• Change of protective earth terminal on FMBB NEO filters case MC and MD

Product Change Notification				PCN FMBB NEO MC MD - earth position				
owner	creation date	release date	released by	change order no	rev	page	D40 020 072	
segatro	07.10.2019	07.10.2019	romanogu	2018488	С	1 of 2	D10-039-972

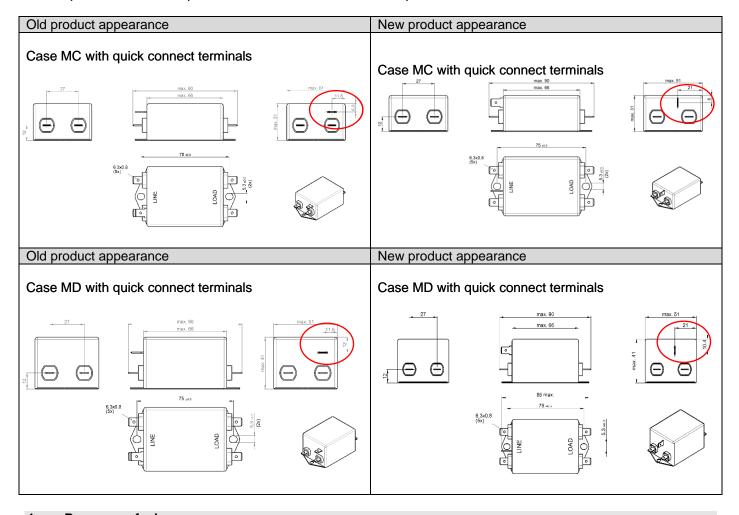
Moved position and turned protective earth terminal to a vertical position

Form Yes Change of position of protective earth terminal
